SITE PLAN MODIFICATION
505 WEST CENTRAL STREET
LOT 3
(515 WEST CENTRAL STREET)
FRANKLIN
MASSACHUSETTS
FIELD CHANGE
PLAN

NOVEMBER 22, 2023

DATE	REVISION DESCRIPTION
1/24/2024	PERVIOUS PAVEMENT REVISIONS

SHEET 1 OF 1 JOB NO. F4383

PROPOSED FIELD CHANGES

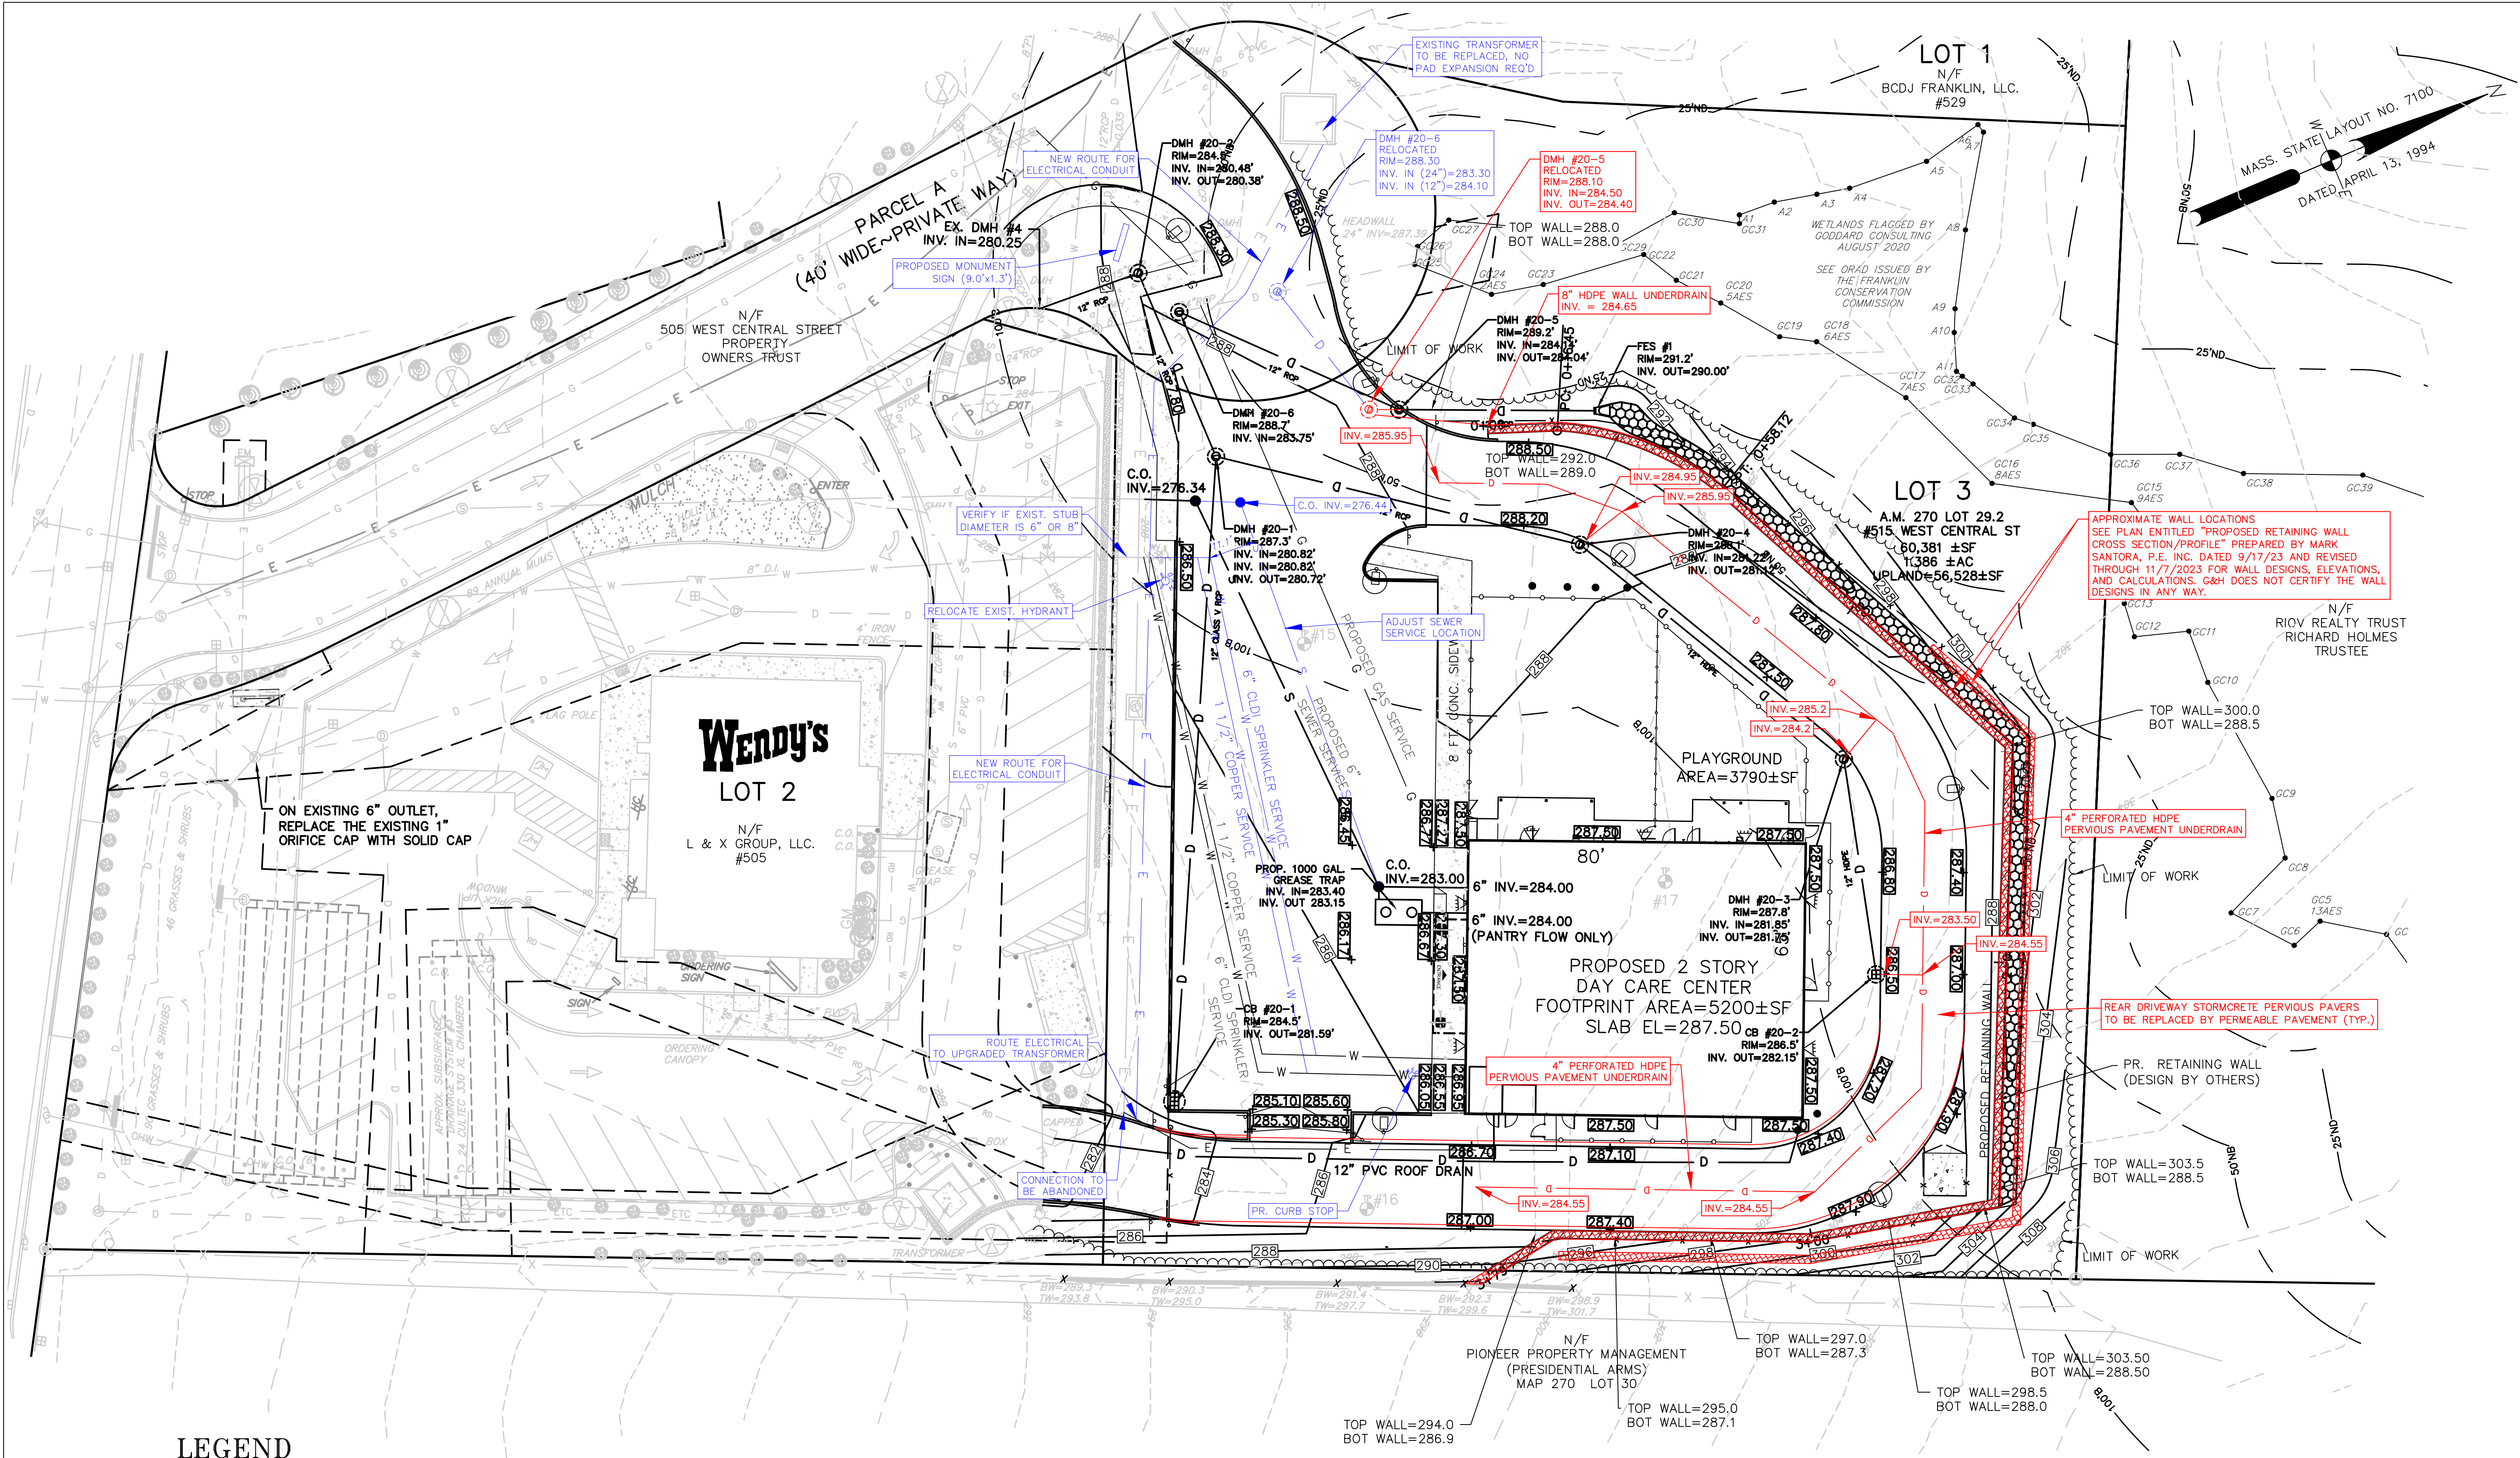
- STORMCRETE PERVIOUS PAVERS TO BE REPLACED BY PERMEABLE PAVEMENT. DUE TO LEDGE AND PERSISTENT HIGH GROUNDWATER BENEATH THE REAR ACCESS ROAD, INSTALLATION OF AN UNDERDRAIN CONNECTED TO THE STORMWATER CHAMBERS IS PROPOSED.

- THE PROPOSED WALL DESIGN IS TO BE A TERRACED DESIGN PREPARED BY MARK SANTORA, P.E. INC. INSTALLATION OF A SUBDRAIN 4" BELOW THE PROPOSED RETAINING WALL IS PROPOSED TO INTERCEPT GROUNDWATER ENTERING THE SITE, AND WILL CONNECT TO DMH #20-5.

- DMH#20-5 AND DMH #20-6 LOCATIONS ADJUSTED TO AVOID CONFLICTS WITH EXISTING AND PROPOSED UTILITIES.
- EXISTING TRANSFORMER AT SITE ENTRANCE TO BE UPGRADED, AND NEW ELECTRICAL SERVICE CONDUIT INSTALLED PARALLEL TO THE EXISTING RUN.

- FIRE AND DOMESTIC SERVICE CONNECTIONS TO BE MODIFIED TO ACCOUNT FOR FIELD CONDITIONS. CONTRACTOR TO VERIFY DIAMETER OF EXISTING STUB. EXISTING HYDRANT TO BE RELOCATED. SEWER SERVICE TO BE ADJUSTED TO MAINTAIN MIN 10" SEPERATION TO WATER SERVICES.

- MONUMENT SIGN PROPOSED AT SITE ENTRANCE.

PERVIOUS PAVEMENT CROSS SECTION
N.T.S.

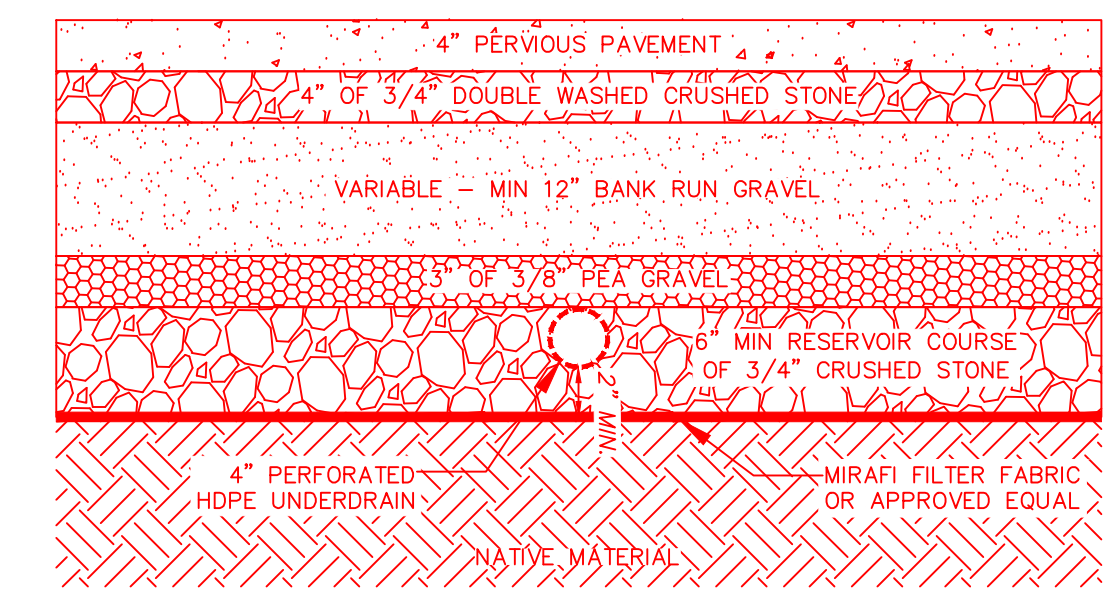
- NOTES:
- PERVIOUS PAVEMENT TO BE PLACED IN TWO 2" LIFTS
 - ALL GRAVEL & CRUSHED STONE TO BE WASHED.
